WETLAND FLAG DELINEATION  
BY NATURAL RESOURCE SERVICES, INC.  
JUNI 4, 2017

DEPARTMENT OF ENVIRONMENTAL MANAGEMENT  
OFFICE OF WATER RESOURCES  
FRESHWATER WETLANDS PROGRAM  
APPROVED WITH CONDITIONS  
AS SPECIFIED IN THE LETTER OF APPROVAL  
DATED NOV 08 2018 FILE # 17-0281  
NO CHANGES ALLOWED WITHOUT PRIOR APPROVAL  
APPROVED PLANS MUST BE AT CONSTRUCTION SITE

N. VELTRI SURVEY, INC. SURVEYING-LAND PLANNING JOHNSTON (401) 231-3200 NARRAGANSETT (401) 789-1300	NO.	DATE	REVISION
WETLAND LOCATION PLAN JOHNSTON, R.I. - APB LOT 287 (PARC. B) FOR: MOHAMMAD Y. SASA		8-18	ORIG. ISSUE
SCALE: 1" = 50' DRAWN: NV		SHEET 1 OF 2 SHEETS	
		CHECKED BY: R.V.

N. VELTRI SURVEY, INC.		NO.	DATE	REVISION
SURVEYING-LAND PLANNING				
JOHNSTON (401) 231-3200				
NARRAGANSETT (401) 789-1300				
<b>PLAN OF PROPOSED OWNTS</b>		2	8/18	REV. PLAN PER DEM COMM.
<b>JOHNSTON, RI. AP 8 LOT 281 (PARC B)</b>		1	2/18	REVISED PER DEM COMM.
<b>FOR MOHAMAD Y. SASA</b>			11/17	ORIG. ISSUE
SCALE 1"=20' DRAWN: NV		SHEET 2 OF 2 SHEETS		
		CHECKED BY: N.V.

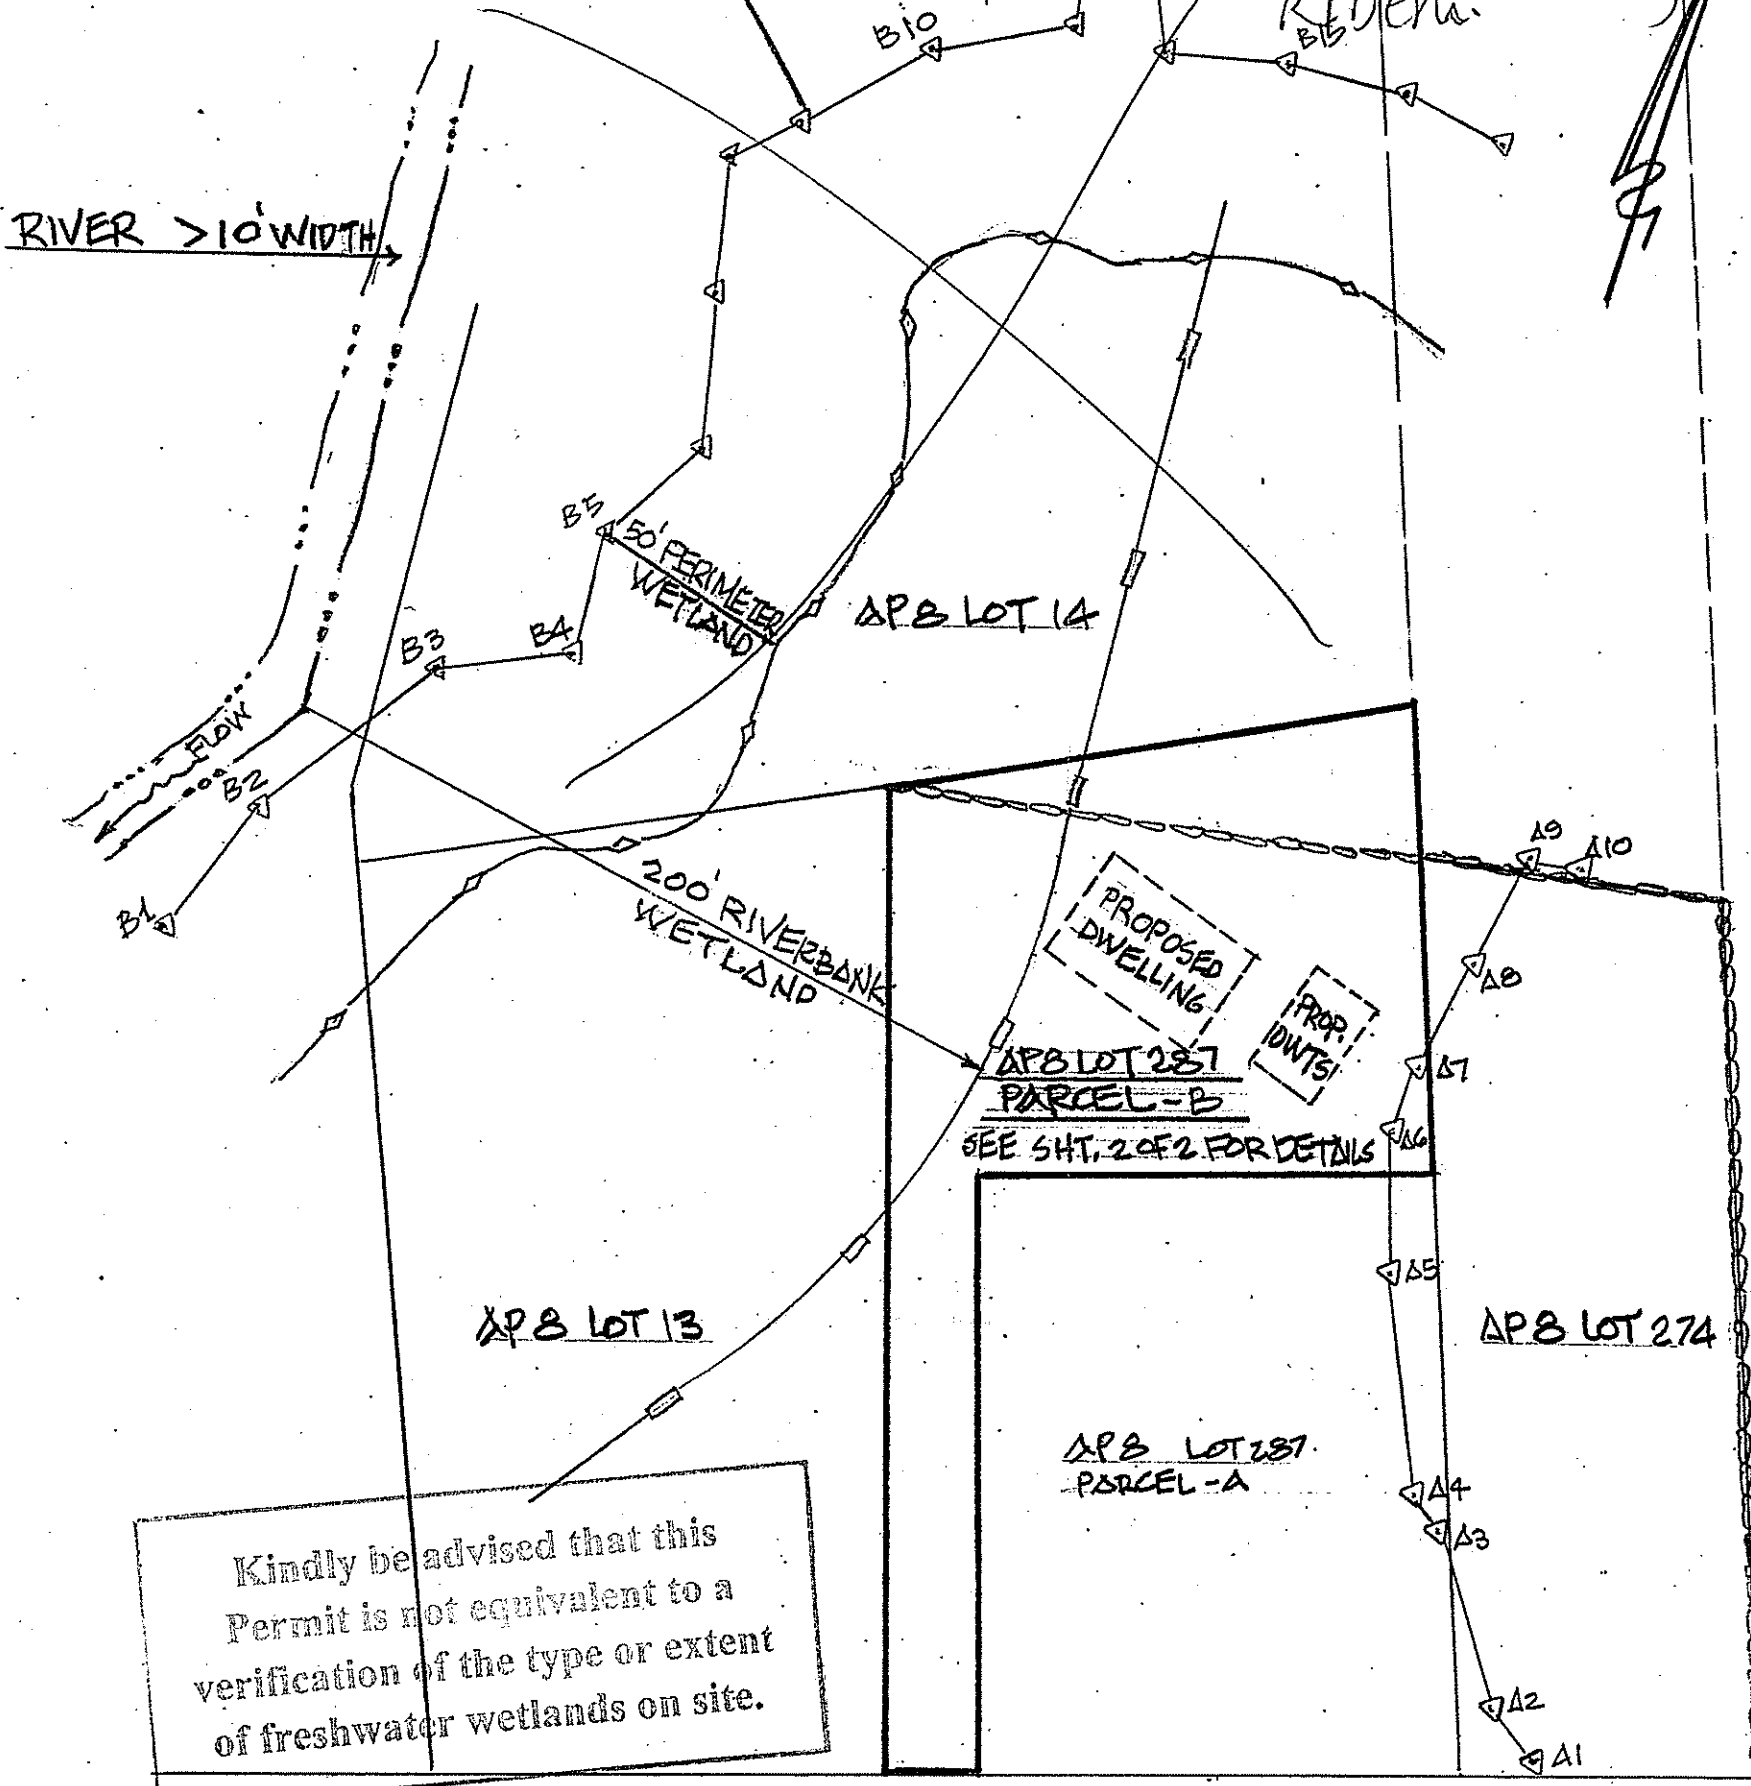
Wetland Edges depicted on A.P. 8,  
Lot 14, have not been reviewed by  
R.D. Dem.

Kindly be advised that this Permit is not equivalent to a verification of the type or extent of freshwater wetlands on site.

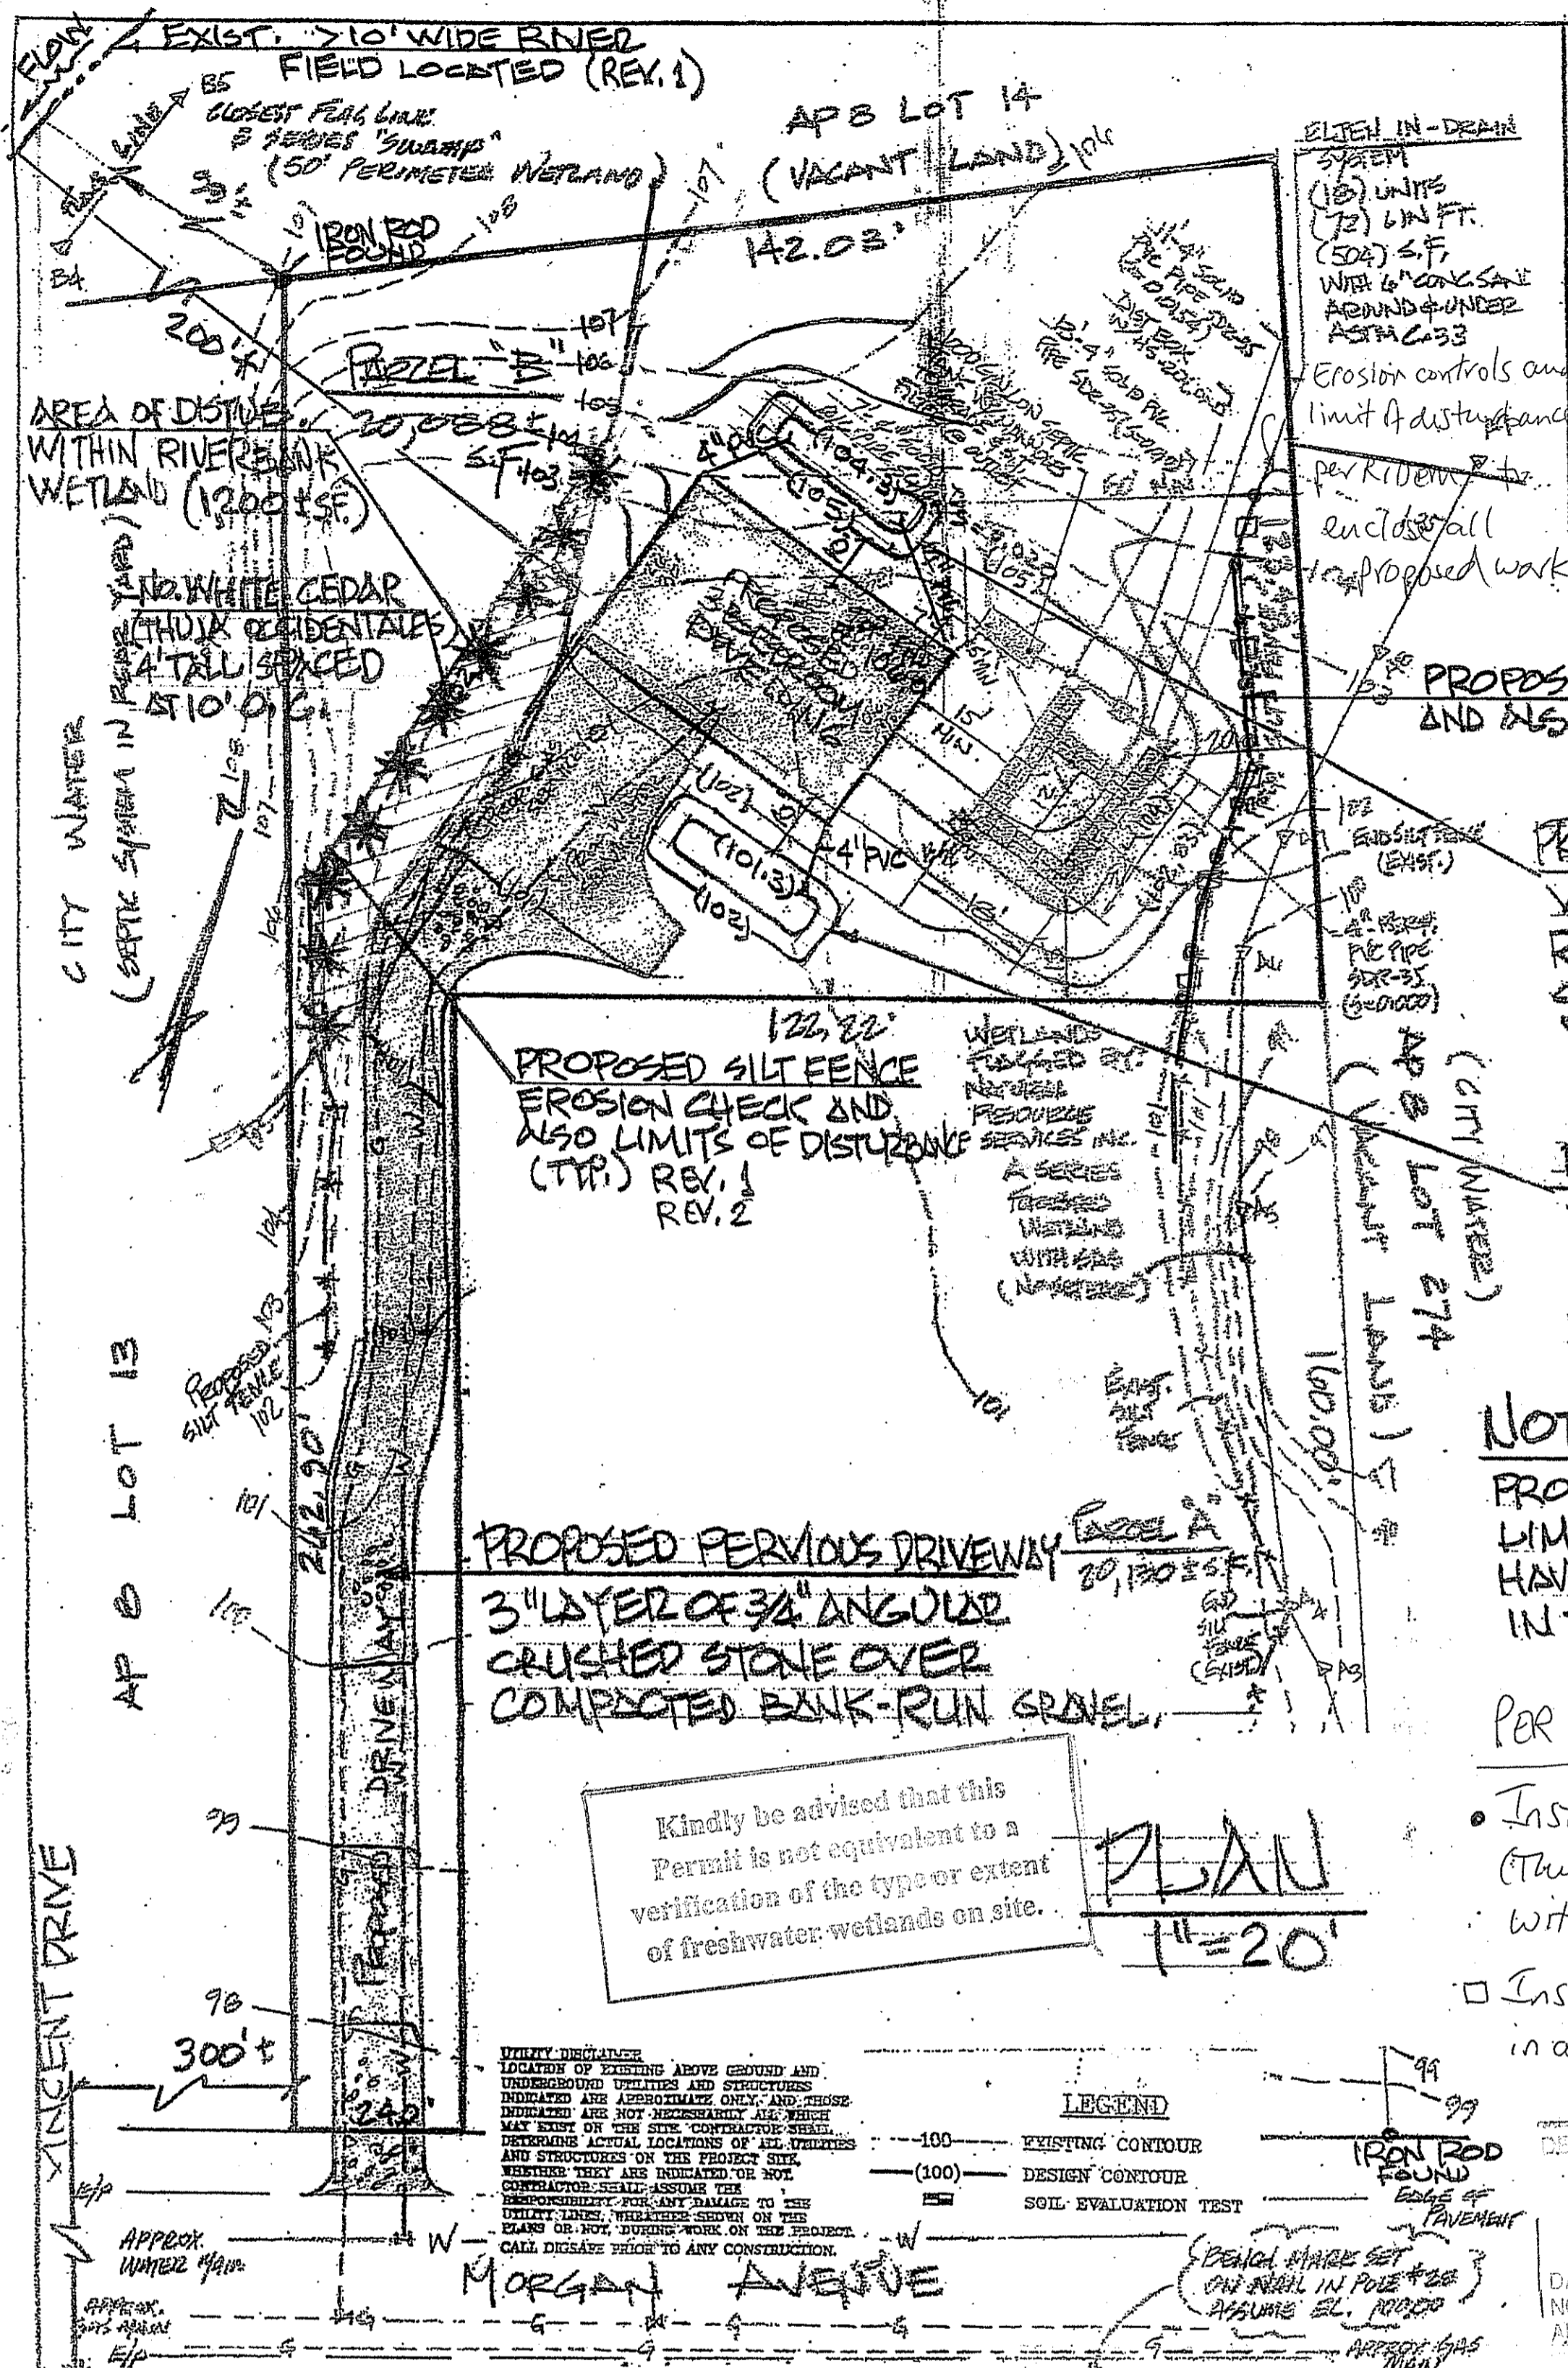
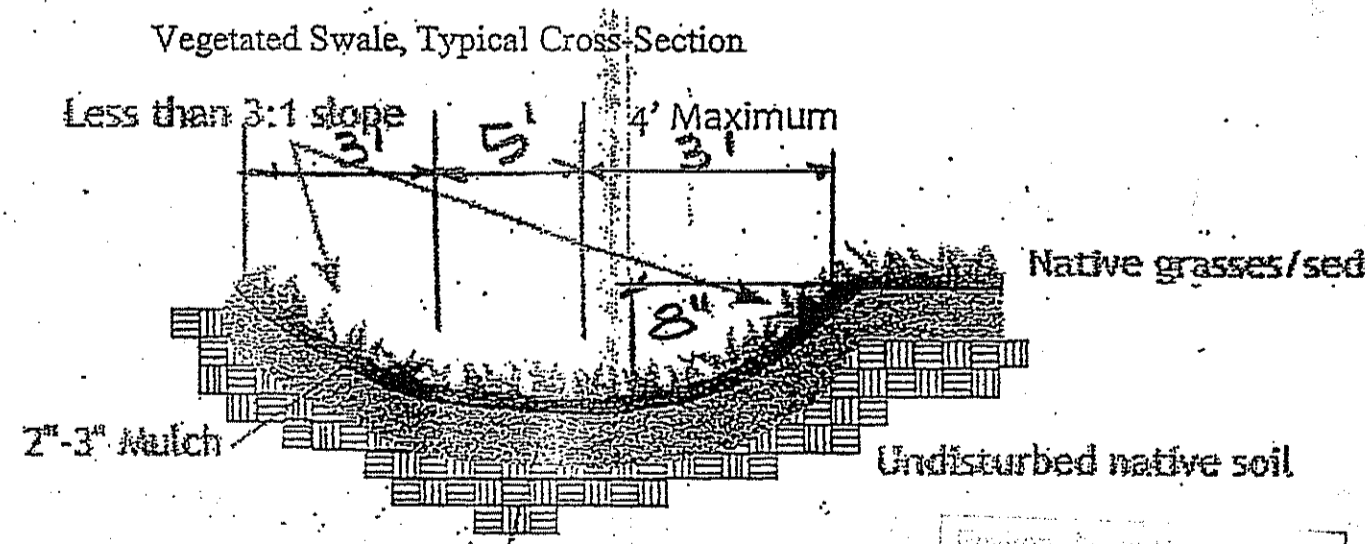
Kindly be advised that this Permit is not equivalent to a verification of the type or extent of freshwater wetlands on site.

- PER RIDEM:**
- Install Northern White Cedars (*Thuja occidentalis*) in accordance with Permit Conditions.
  - Install buffer zone markers in accordance with Permit Conditions.
